- 7. Sunset View Estates Addition No. 2  
KPB File 2023-041**

### Sunset View Estates Addition No. 2

ITEM 7 – SUNSET VIEW ESTATES ADDITION NO 2

STAFF REPORT

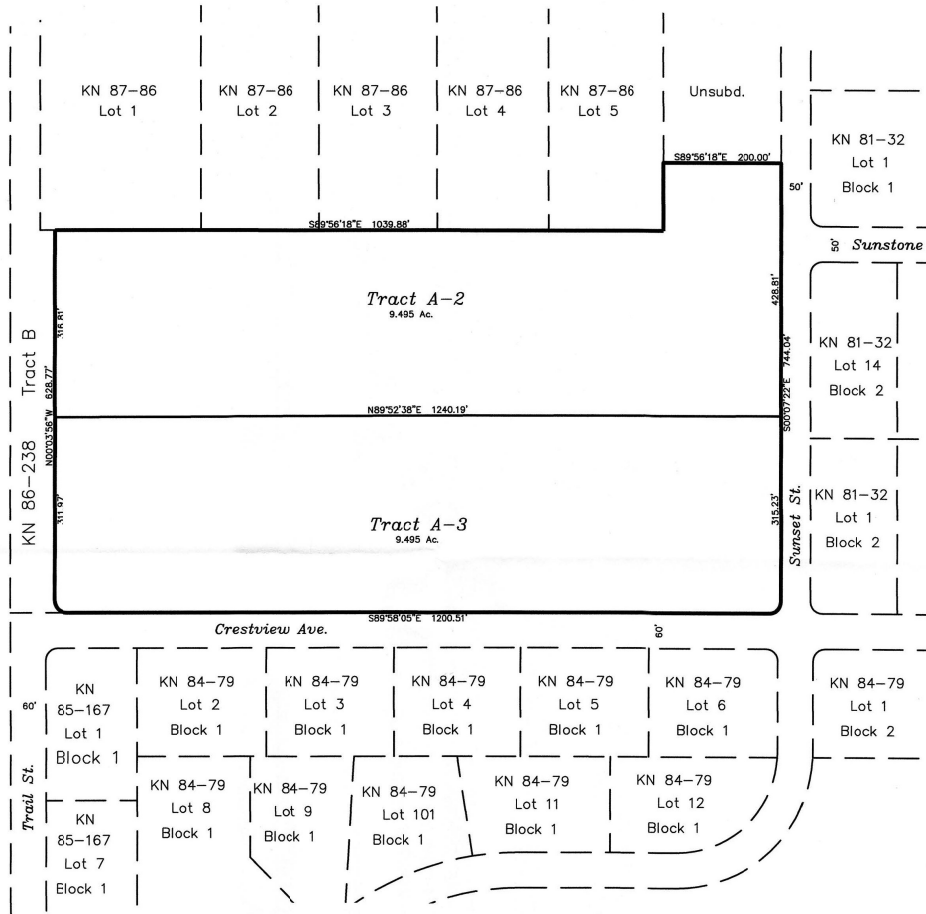
- Staff recommendation:** Verify the acreage and update the title block.
- C. The location, width, and name of existing or platted streets and public ways, railroad rights-of-way, and other important features such as section lines or political subdivisions or municipal corporation boundaries abutting the subdivision;

- Staff recommendation:** Add Ave to Sunstone to the East. Add to the road to the south the name and width.
- D. A vicinity map, drawn to scale showing location of proposed subdivision, north arrow if different from plat orientation, township and range, section lines, roads, political boundaries, and prominent natural and manmade features, such as shorelines or streams;

- Staff recommendation:**  
To the northeast, change Lot 1 to Lot 2.  
To the south Lot 101 needs changed to Lot 10.
- J. Block and lot numbering per KPB 20.60.140, approximate dimensions and total numbers of proposed lots;

- Staff recommendation:** Need distance and bearing on west side of job to the north. Need distances corrected on north and south line to match parent plat to correct west line of parcel.

- Staff recommendation:** Steep slopes present but not shown, show tops and toes of slopes on final.

**Staff recommendation:** *Depict and label 20' setback line on drawing.*

*Need to add a bearing and distance to the line adjacent to lot 5 on the north.*

*East/west lines need to be adjusted to the correct west limit of Lot A-1, with the correct west line of the subdivision dimensioned.*

*Dimension the curve in the southeast corner.*

*Need to add the 10 utility easement on the south line as dedicated by KRD 86-238 and note the source. Need to add the 20' x 30' utility easements across from Sunstone Ave as shown on KRD 86-238 and note their source. Depict the new utility easements been granted along the right away. Discussed under utility easements.*

*The plat notes numbers need to be revised.*

*Plat note 4 is only required if a dedication is being granted by the plat. Include "(KPB 14.06)" if it remains on the plat.*
